Access Compliance Report

Public Rights-of-Way

(Curb Ramps)

Intersection ID: 13708	Main Street: WEST_BV	Cross Street: WICKFORD_PL	Location: NE
ADA ID: 95130E66D77D	Ramp Type: Perp	Initial Pass/Fail: Fail	Overall Compliance: No
		Severity Score: 12.5

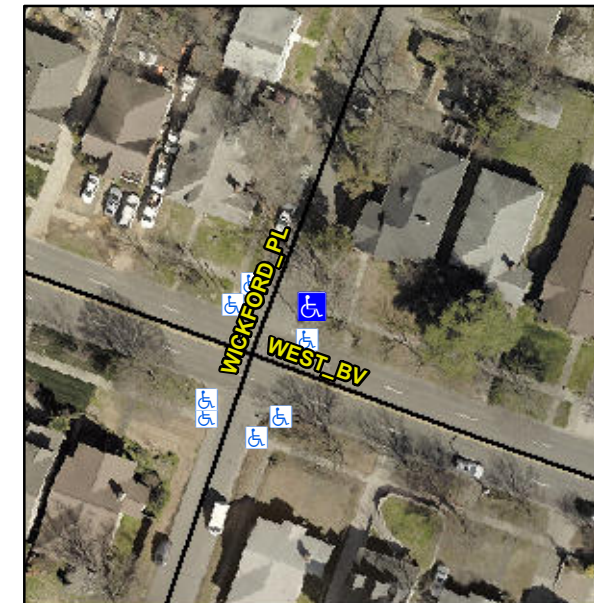
Not Found, R304.2.2

Compliance	Description	Data	Compliance	Description	Data
N/A	Ramp Length (in)	62.0	No	Ramp Slope (%)	9.9
Yes	Ramp Width (in)	60.0	Yes	Ramp XSlope (%)	1.3
N/A	Flare Type LT	N/A	N/A	Flare Type RT	N/A
N/A	Flare Slope LT (%)	N/A	N/A	Flare Slope RT (%)	N/A
N/A	Flare Traversable LT?	N/A	N/A	Flare Traversable RT?	N/A
N/A	Landing Length (in)	N/A	N/A	DWS Provided?	N/A
N/A	Landing Width (in)	N/A	N/A	DWS Contrast?	N/A
N/A	Landing Slope (%)	N/A	N/A	DWS Length (in)	N/A
N/A	Landing X Slope (%)	N/A	N/A	DWS Full Width?	N/A
N/A	Landing Curb? (Y/N)	N/A	N/A	DWS Offset (in)	N/A
N/A	Shared Landing?	N/A			
N/A	Gutter Ponding?	Yes	N/A	Gutter Slope (%)	N/A
N/A	Gutter Lip Ht (in)	N/A	N/A	Gutter X Slope (%)	N/A
N/A	Painted X Walk1?	No	N/A	Painted X Walk2?	N/A
	X Walk 1 Direction	To NW		X Walk 2 Direction	N/A
N/A	X Walk 1 Width (in)	N/A	N/A	X Walk 2 Width (in)	N/A
	X Walk 1 Slope (%)	0.4		X Walk 2 Slope (%)	N/A
	X Walk 1 X Slope (%)	0.5		X Walk 2 X Slope (%)	N/A

Remove & Replace Entire Ramp.
